RE: GULF SERVICE STATION
WASHINGTON & OCEAN AVENUES
PORTLAND, MAINE

A.P.- 797-809 Washington Avenue

A preliminary check of your building plans has been made but we are unable to issue a building permit until the application has been completed by paying the permit fee based on the building cost and by showing compliance with the City of Portland Zoning Ordinance and Building Code as follows:

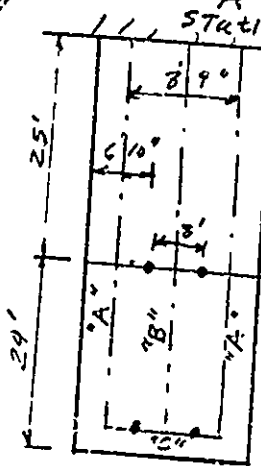
1- V.S.L. -	1- Service Storage	1202-C-3-C
2- Location & Reparatons	2- O.K. > 30' to property lines	Fire Dept
3- Class of construction	3- Not permitted for 3rd	with 12' minimum
2nd class construction	Class construction.	1st fl 11 feet 6"
wood frame roof & masonry		4.5
walls.		30
Height & area O.K.		1935.0 R'
4- Light & Ventilation	4- Exhaust fans minimum in	
	toilet rooms Mt. ER-75C	
5- Egress	5- 2 means of egress (503.5.3.1)	O.K.
6- Fire Protection - toilet room	6- Cement floor	O.K.
7- Sanitation	7- Same as general	O.K.
8- Heat: Hot air - Fan	8- Unit heater - Fire Dept	- Flame 8' above
9- Special Provisions	Heater room enclosed.	floor
	9- Floor drains - Plumbing Dept	O.K. if Extra
		heavy pipe - is
		used inside &
		out
		O.K.
10

Construction
 - Extra heavy pipe needed for
 catch basin & to sewer.
 Plumbing Inspector -
 - Permits for -
 (1) Signs
 (2) Heat by installer
 (3) Permit for Bhy. new underground
 tanks.
 - Payment of fees
 - Brick ties
 - Unit heater shall have flame at
 least 8' above the floor

Structural check

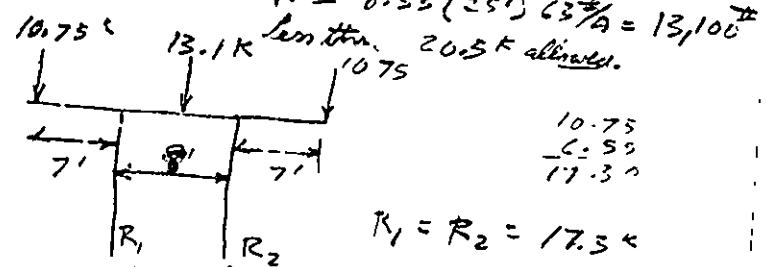
All be 5 10" W 33"
 check beam "A"
 $V = 6.83 \times 25 \times 13 \frac{1}{16} = 10,750$
 Reg'd $10,750$
 $W_{allow} = 895$
 $\frac{8(22)ksi \cdot 35A^2}{25' \times 12'} = 20.5$
 ALLOW

OK in bending
 Deflection

$\Delta = \frac{0.02276 L^2}{10}$
 $= \frac{0.02276(25)(25)}{10} = 1.42"$
 $\frac{25' \times 12'}{360} = .75"$ for plaster

check beam "B"

$R_1 = R_2 = 17.3$
 $M_{cantilever} = 10.75 \times (7') = 82.3$

$M_{conc} = PL/4 = \frac{13.1(8)}{4} = 26.2$

$Stress = \frac{M}{S} = \frac{82.3 \times (12^3/12)}{22 ksi} = 45$
 > 35 ksi

- 8.) Since you have raised the question on the adequacy of the cantilevered section of Beam "C" supporting canopy roof section for design loads, I am attaching for your information a complete photostatic copy of the computations we made in designing this canopy and from these you will note on page 8 that Beam "C" for the inboard island support for two canopies has a maximum negative moment and resulting fiber stress of 20,200 lb. per sq. in. which is well under the allowable for A-36 steel. This Beam "C" which is called Beam "F" in the Calculations is on the outboard island support and you will note includes some rather voluminous calculations arriving at the torsional stresses due to the cantilevered overhang on the side of the beam, and from this on Page 11 of the Calculations they are well within the allowable of 22,000 lb. per sq. in.
